GROUP	MODEL
Safety Recall Campaign	2014-2016MY Cadenza (VG)
NUMBER	DATE
SC284VG (Rev 1, 9/19/2024)	June 2024

HECU MULTI FUSE REPLACEMENT (SC284VG)

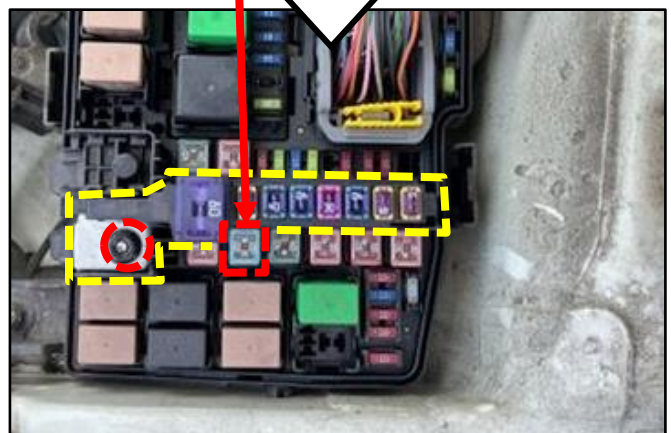
- 4a. Locate the Multi Fuse (A) for ABS1 and loosen the 10mm Multi Fuse retaining nut (B) and remove the Multi Fuse.

- 4b. Install the new Multi Fuse (A) and tighten the retaining nut (B).

- 5a. Remove the existing HECU ABS2 30A fuse (C).

- 5b. Install new amperage fuse:

- ABS2 fuse (C) → new 20A

Tightening torque for retaining nut (B):
7.2 - 8.7 lb.ft (9.8 - 11.8 N.m)

Note: Drill a hole through the center of the removed Multi Fuse. DO NOT reuse.
